Form C-103
Revised July 18, 2013

WELL API NO. 30-015-34838
5. Indicate Type of Lease STATE <input type="checkbox"/> FEE <input checked="" type="checkbox"/>
6. State Oil & Gas Lease No.
7. Lease Name or Unit Agreement Name Stirling 7 C
8. Well Number 004
9. OGRID Number 372290
10. Pool name or Wildcat Red Lake
11. Elevation (Show whether DR, RKB, RT, GR, etc.) 3288

NEW "2024" COA's

Stirling 7 C 4
Procedure to P&A
AFE: 23PA00
API # 30-15-34838
990' FNL & 1650' FWL
7-18S-27E
Eddy County, New Mexico

Well Name: Stirling 7 C 4

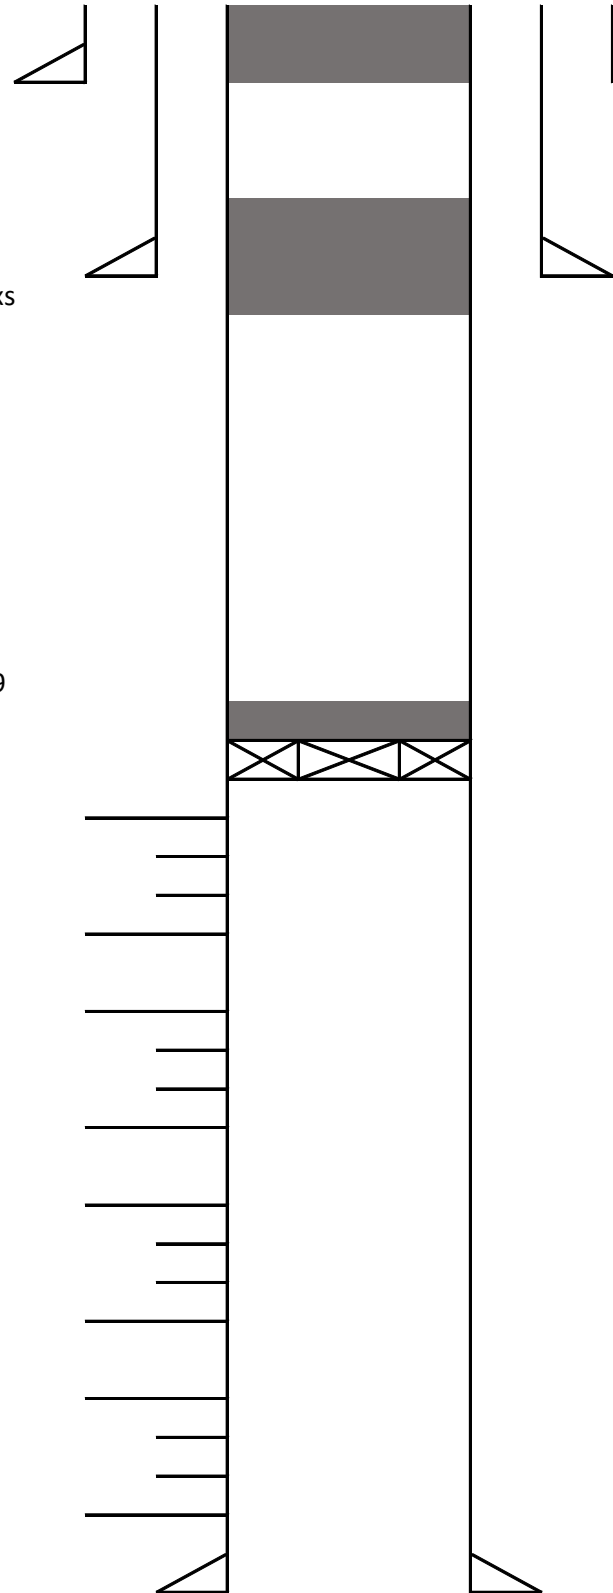
3 45 sx cement 233 to surface

2 85 sx cement 1115-700 (8 5/8" shoe & Grayburg)

1 Set 5 1/2" CIBP @ 2490'. Circulate hole w/MLF.
Pressure test casing. Spot 25 sx cement @ 2490-2290. (Glorieta)

- 10) Spot 25 sx cement plug @ 2490' - 2290'. **WOC & Tag**
- 11) Spot 85 sx cement plug @ 11**70**'-700'. **T SA**
- 12) Spot 45 sx cement plug @ 2**50**'-Surf.
- 13) Cut off wellhead. Verify cement @ surface **on all strings**
- 14) Weld on dry hole marker.
